BOLLETTINO TECNICO

N° **109-129**

SUBJECT: INCLUSION OF POWER TURBINE N2 LIMITATIONS.

REASON: Prescribe operational limitations for the power turbine speed in accordance with information provided by engine TCH (ref. Rolls-Royce C.E.B A-1400 Rev. 3), until the affected components have been replaced.

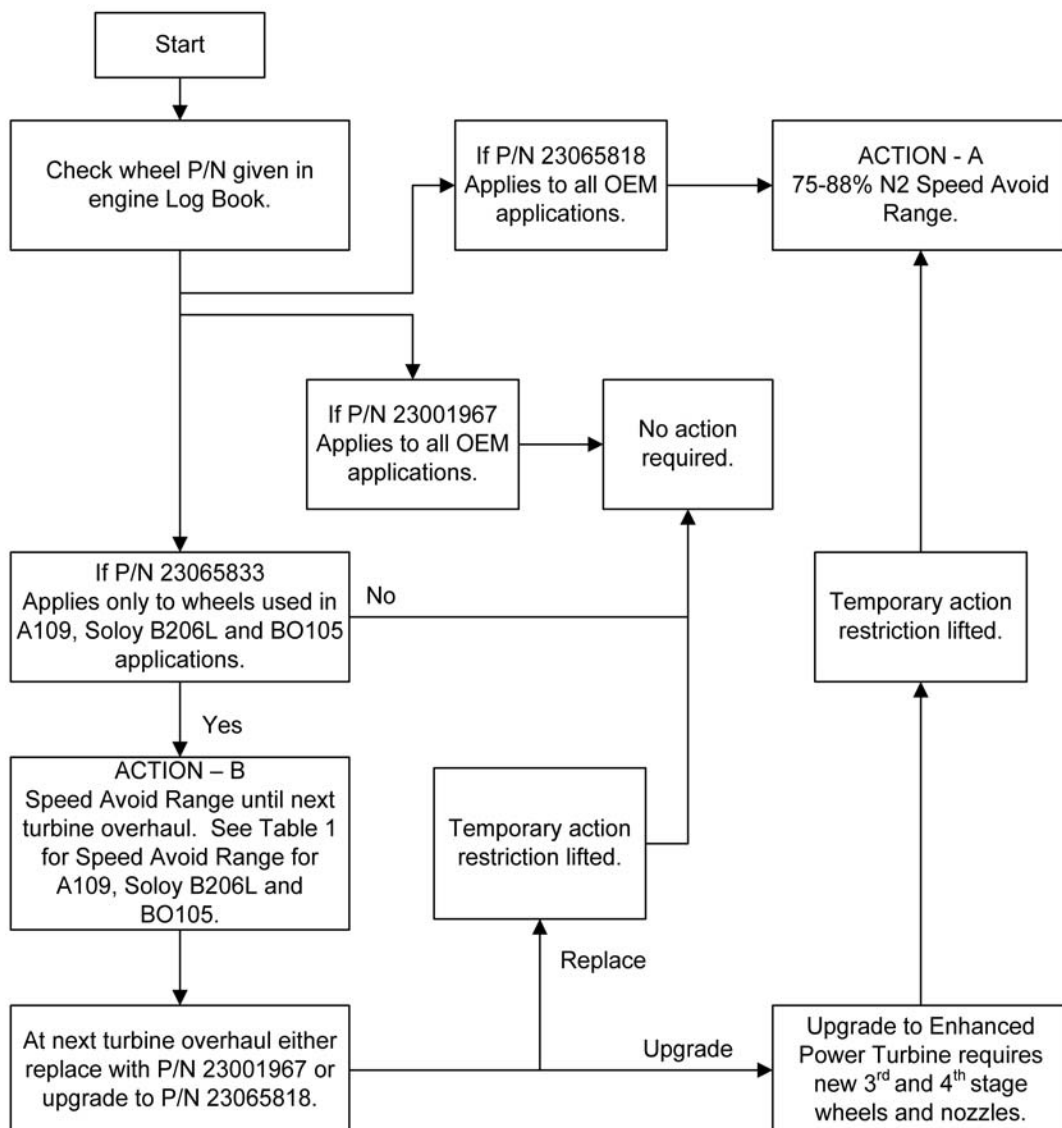
The part number of the 3rd-stage turbine wheel installed in a Model 250 Series II engine is recorded in the engine logbook, Turbine Assembly (pink pages), Assembly Record, Part V. The part number must be used to identify the appropriate action described in paragraph 2.B. or 2.C. The following flowchart is included as a simple guide to help identify the appropriate action for each wheel type.

NOTE: A temporary action only is required for the Agusta A109 (all models), Soloy B206L/R and Eurocopter BO105 (all models) with the non-enhanced 3rd-stage turbine wheel P/N 23065833 installed, since this wheel will be permanently removed from service at the next turbine overhaul (replacement options are discussed in paragraph 2.C.(1)(d)). All other OEM applications with the non-enhanced 3rd-stage turbine wheel P/N 23065833 installed do not require a temporary action.

250-C20 Maximum Allowable Output Shaft Speeds
FIG. 1

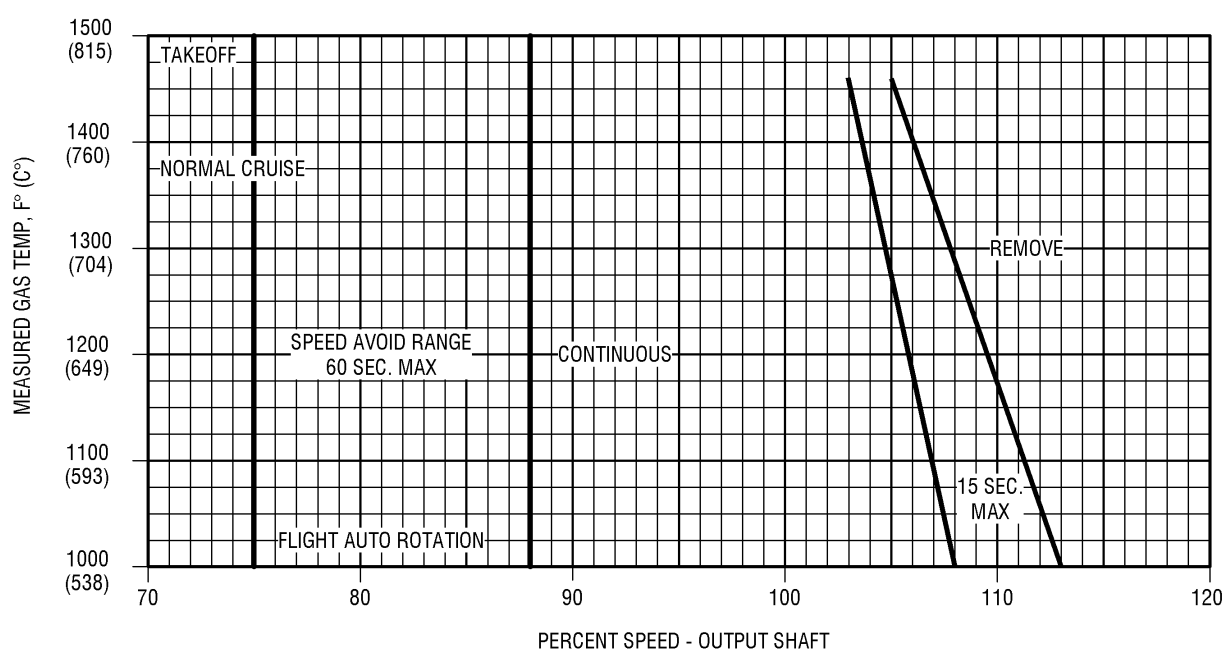
Steady-state operation below 85 SHP or transient operation passing through this speed range is allowable. This action applies to all flight and ground maintenance (including track and balance) operational practices (Ref. FIG. 1, 2, 3 and 4).

TRANSITION THROUGH THE SPEED AVOID RANGE IS TO BE ACCOMPLISHED AS EXPEDIENTLY AS POSSIBLE.

250-C20B, -C20F, -C20J, -C20W Maximum Allowable Output Shaft Speeds
FIG. 2

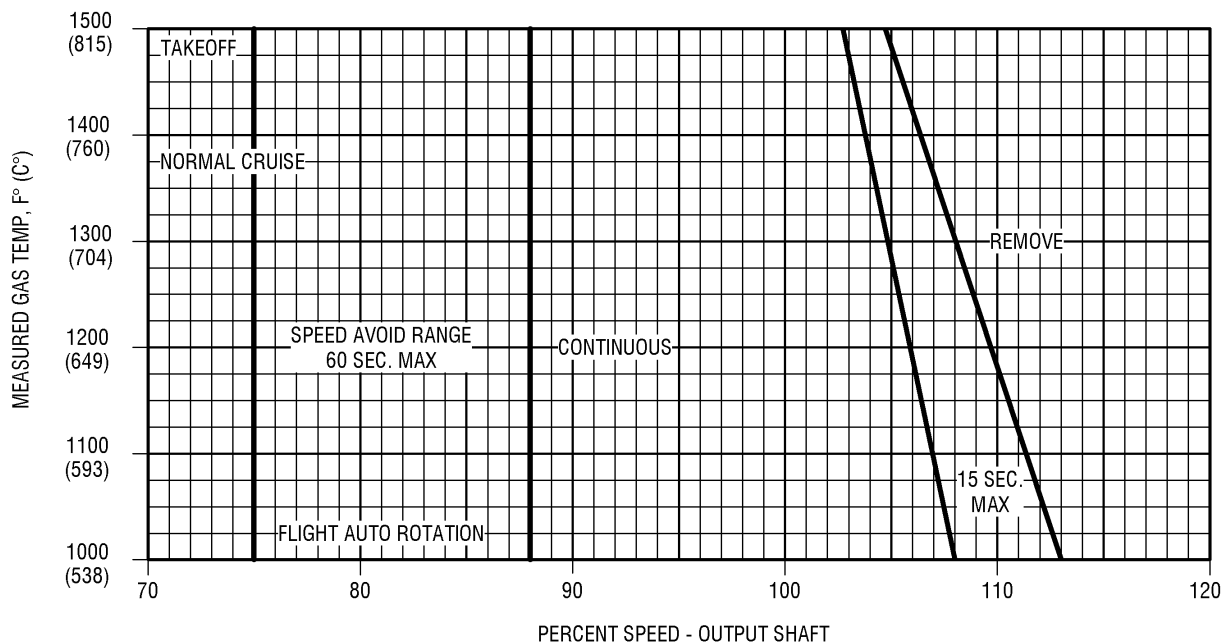
TRANSITION THROUGH THE SPEED AVOID RANGE IS TO BE ACCOMPLISHED AS EXPEDIENTLY AS POSSIBLE.

250-B17, -B17F, -C20S Maximum Allowable Output Shaft Speeds
FIG. 3

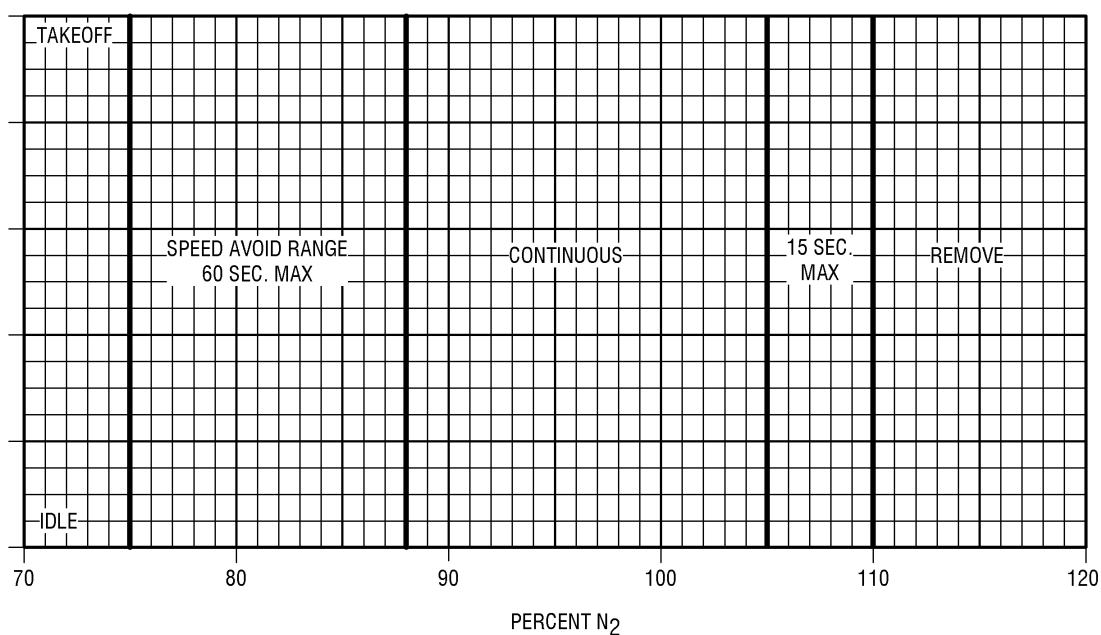
TRANSITION THROUGH THE SPEED AVOID RANGE IS TO BE ACCOMPLISHED AS EXPEDIENTLY AS POSSIBLE.

250-C20R Maximum Allowable Output Shaft Speeds
FIG. 4

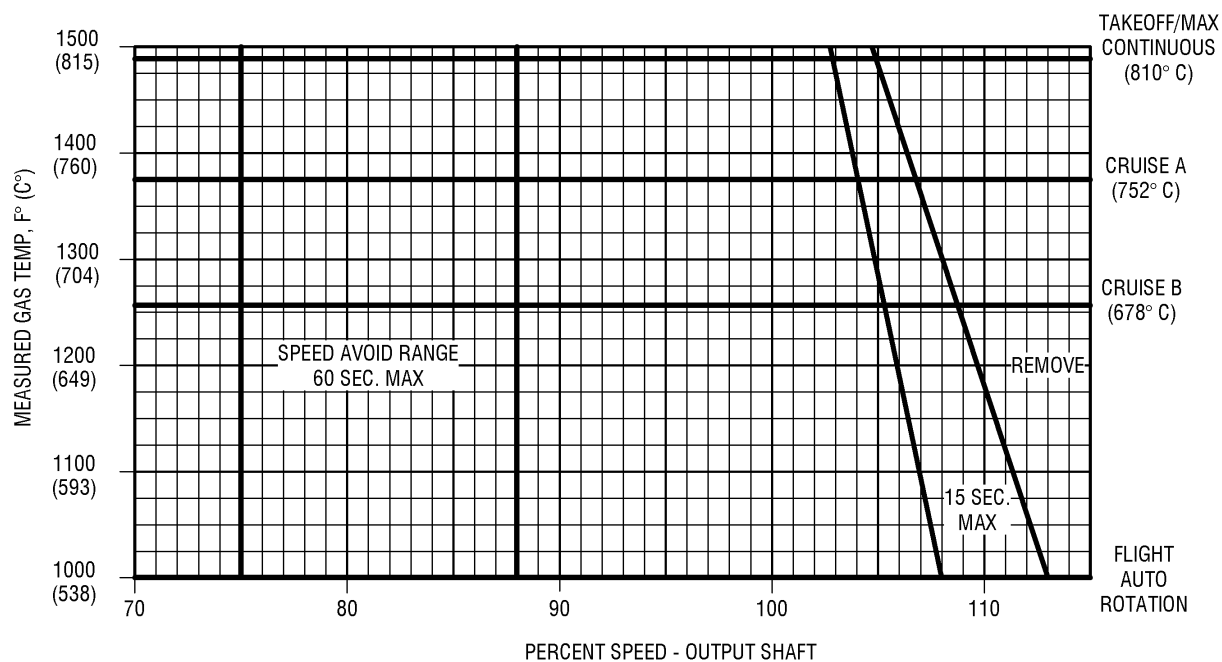
TRANSITION THROUGH THE SPEED AVOID RANGE IS TO BE ACCOMPLISHED AS EXPEDIENTLY AS POSSIBLE.
